[Docket No. FAA–2016–9418; Product Identifier 2016–NE–23–AD; Amendment 39–19167; AD 2018–02–14]

#### **Airworthiness Directives; Honeywell International Inc. Turboprop and Turboshift Engines**

**ACTION:** Final rule.

**Figure 1 to Paragraph (h) of this AD. Combustion Chamber Case Assembly Without the One-Piece Bleed Pad with P3 Boss**

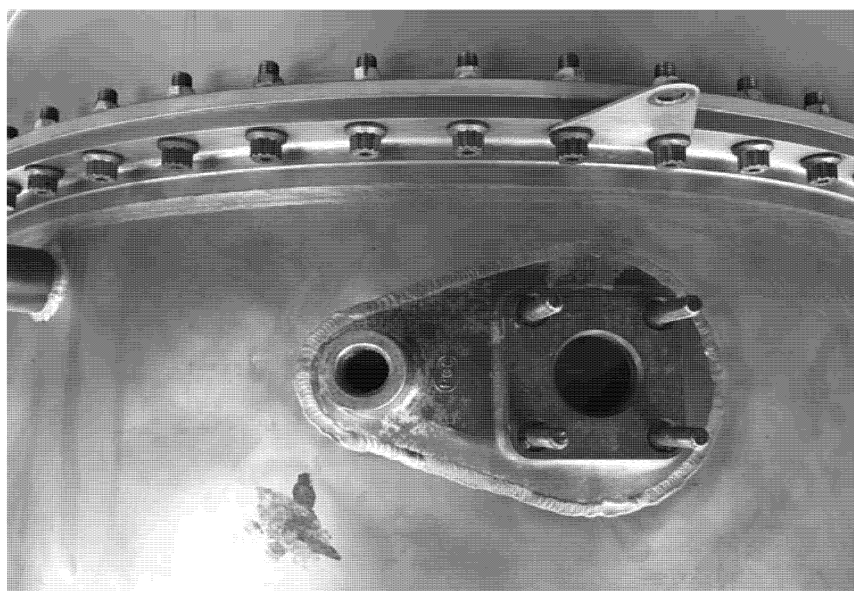
We agree. We note that five of the six combustion chamber case assemblies that ruptured were assemblies without the one-piece bleed pad. P/N 3101668-x has the one-piece bleed pad with P3 boss, which demonstrated significantly reduced cracking between the P3 and bleed boss; therefore, this combustion chamber case assembly is not affected by this AD. No further changes are needed. We did not change this AD.

TPE331 model engines modified by STC SE383CH may be defined as the “Super 1” and “Super 2” for the compressor modification of the TPE331–1 and the TPE331–2, –2U, and –2UA engines, respectively. Figures 1 and 2 to paragraph (h) of this AD illustrate the appearance of combustion chamber case assembly, P/N

893973-5, without and with, respectively, the one-piece bleed pad with the P3 boss.
